To: INCITS T10 Committee  
From: Susan Gray, Quantum  
Date: December 8, 2003  
Document Number: T10/04-014r0  
Subject: ADT SCSI Application Diagrams

Section 8 of ADT describes the mapping between SCSI protocol services defined in SAM-2 and the services provided by ADT. In previous group discussions, it was mentioned that it would make the section more understandable if diagrams were provided. This proposal is to add diagrams for clarification.

This proposal applies to ADT Revision 9.

Figure X SCSI Command with no data phase

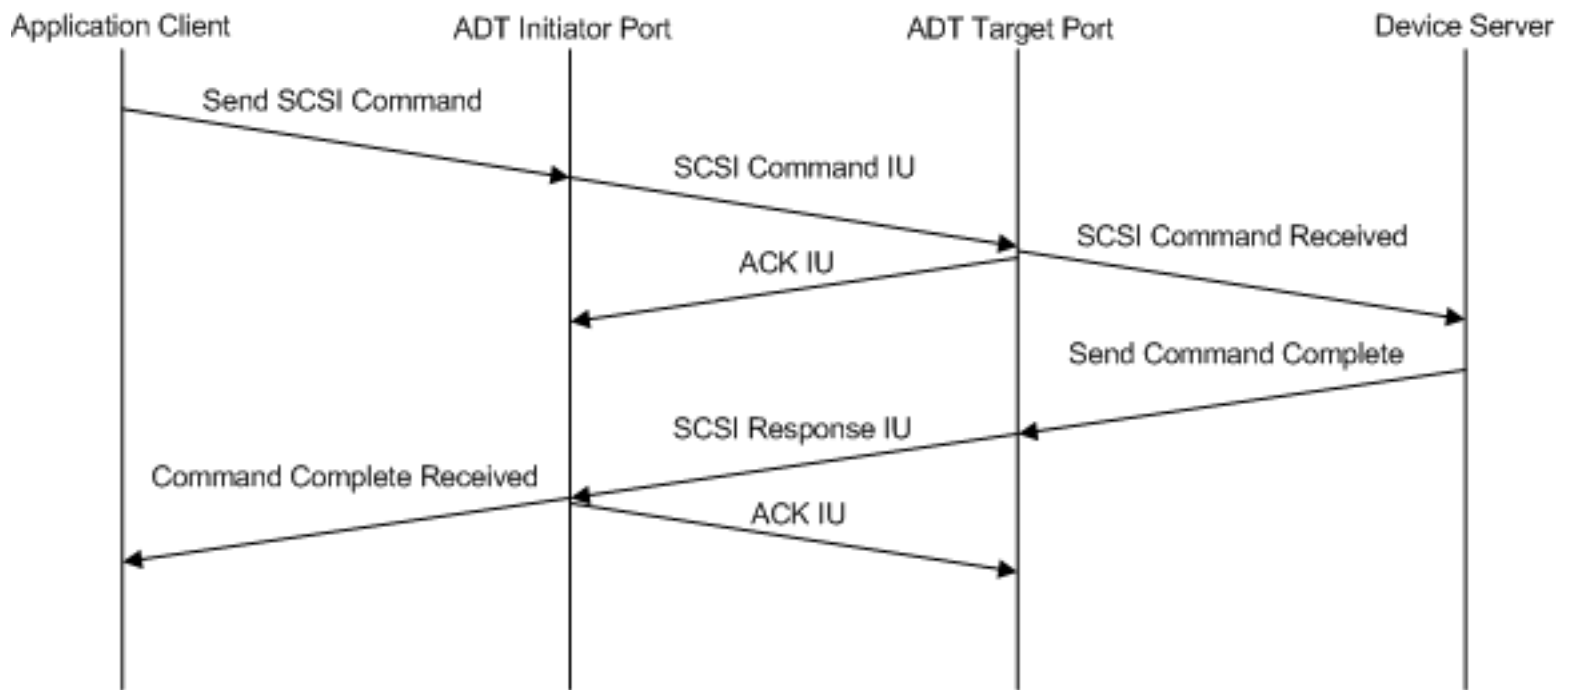
Figure x shows how SCSI transport protocol services may be used to process a SCSI command that has no data phase. This figure assumes an error free exchange.

Figure x + 1 SCSI Command with Data In

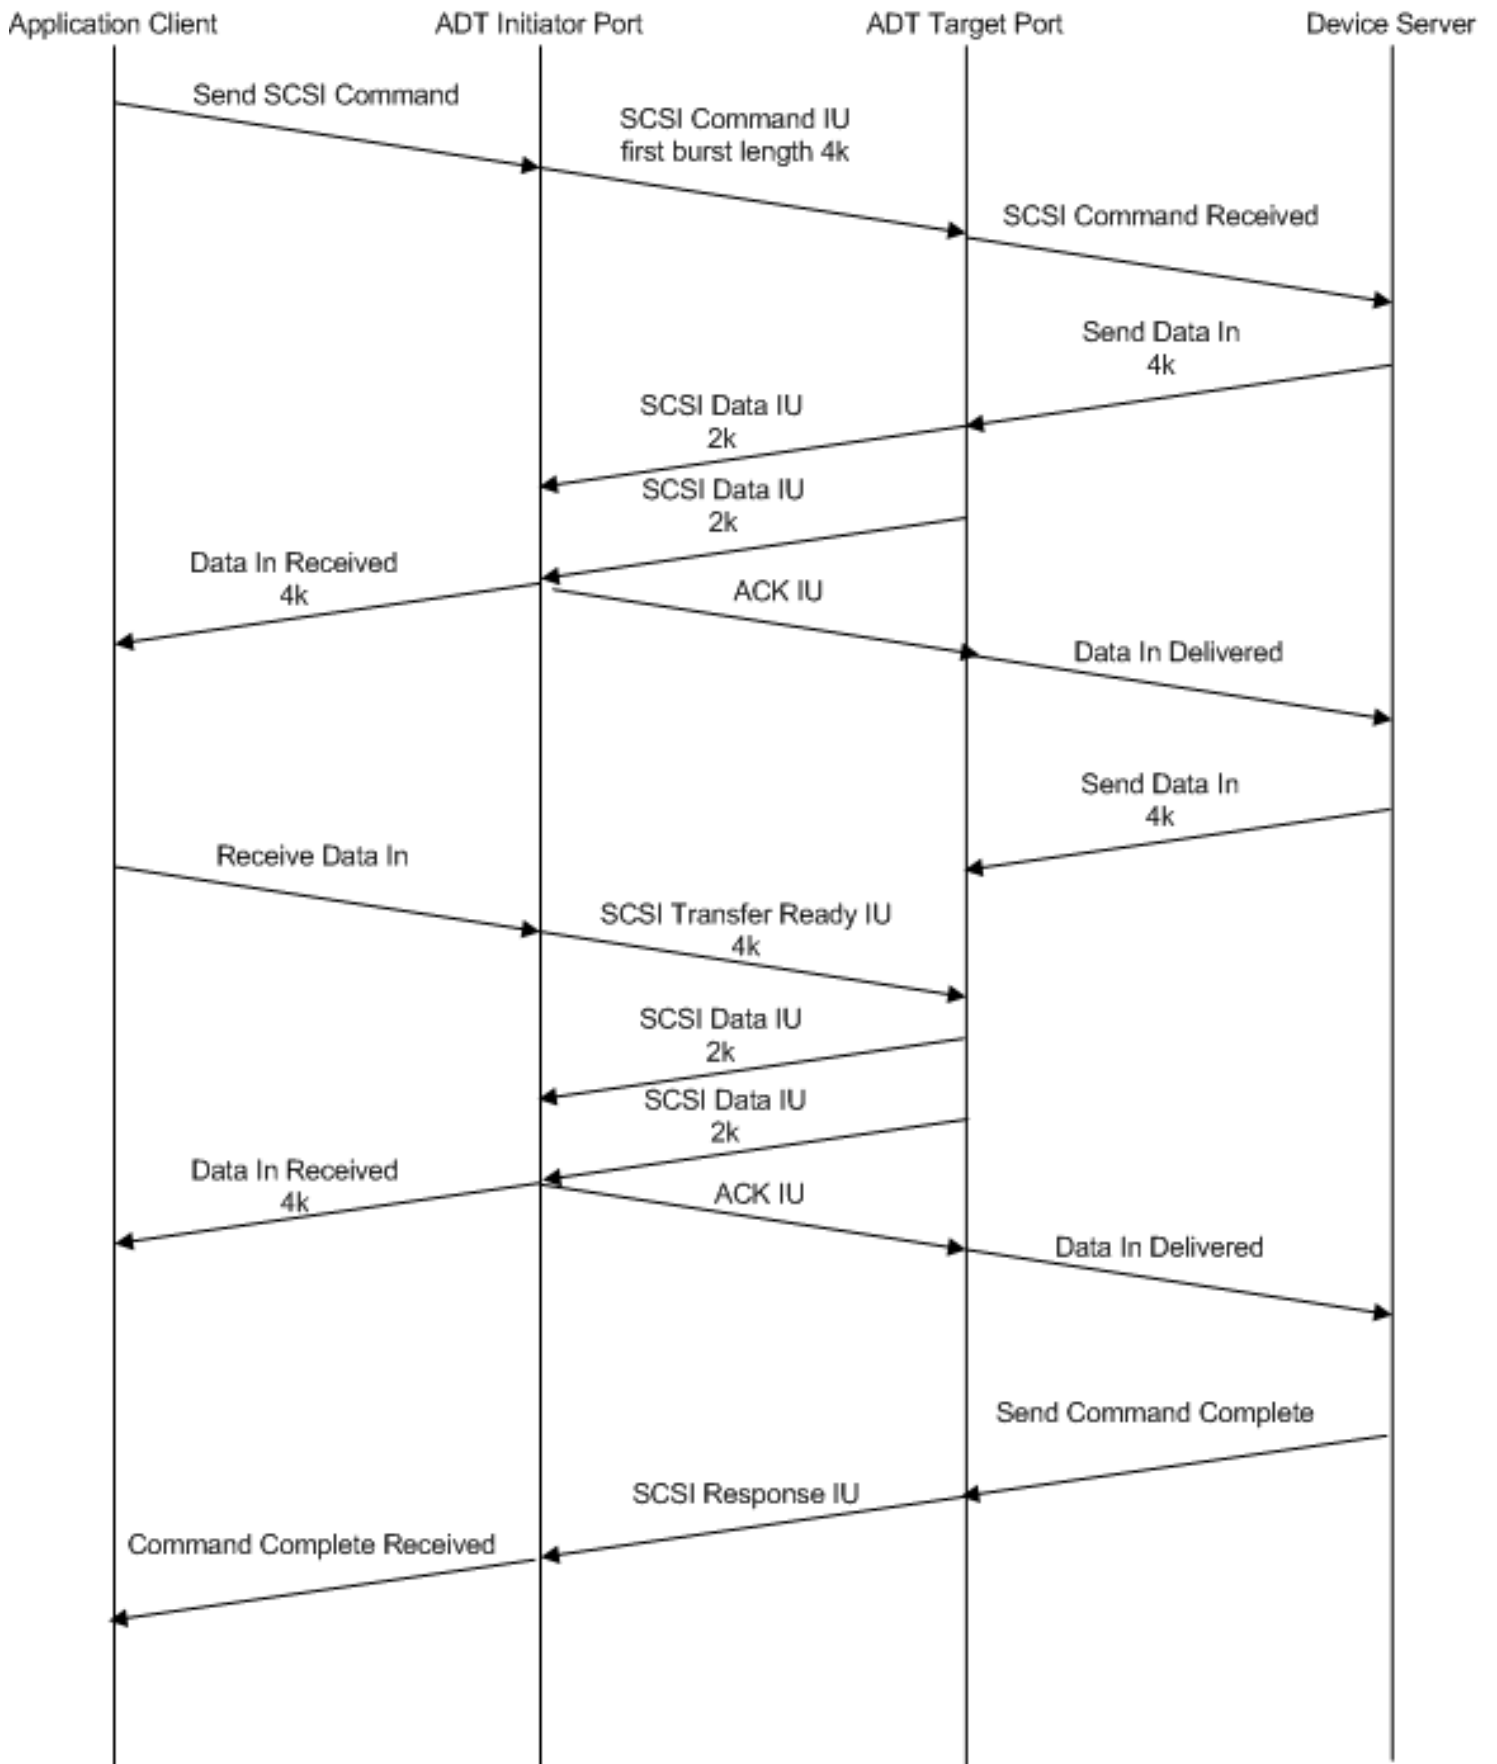
Figure x + 1 shows how SCSI transport protocol services may be used to process a SCSI command with a data-in phase. All IUs transferred between the ADT ports must be acknowledged. Most of the ACK IUs are not shown in this figure in an effort to make it more readable. The ACK IUs that are shown are those that have a direct impact on the communication between the ADT target port and device server.

This example shows a SCSI command that has an overall data-in length of 8k. The SCSI Command IU has a FIRST BURST LENGTH field value of 4k which has the effect of a SCSI Transfer Ready IU with a BUFFER OFFSET field of zero and a BURST LENGTH field of 4k (see 7.1.2). The device server then requests 4k of data to be transferred to the application client. The ADT target port uses multiple SCSI DATA IUs to transfer the data to the ADT initiator port. Once it has received the FIRST BURST LENGTH number of bytes it will send a Data-In Delivered confirmation to the application client. Once the last SCSI Data IU has been acknowledged, the ADT target port will notify the device server using the Data-In Delivered confirmation.

The device server may send more data at any time using the Send Data-In request, but the ADT target port shall not transfer the data until it has received a SCSI Transfer Ready IU (see 7.1.5). When the application client issues a Receive Data-In request, the ADT initiator port shall transmit a SCSI Transfer Ready IU. The ADT target port shall respond by transmitting data using one or more SCSI Data IUs until BURST LENGTH bytes of data have been sent.

When the device server has completed sending all the data-in for the command, it uses the Send Command Complete protocol service to request the ADT target port transmit a SCSI Response IU. Upon receiving the SCSI Response IU, the ADT initiator port shall notify the application client using the Command Complete protocol service.
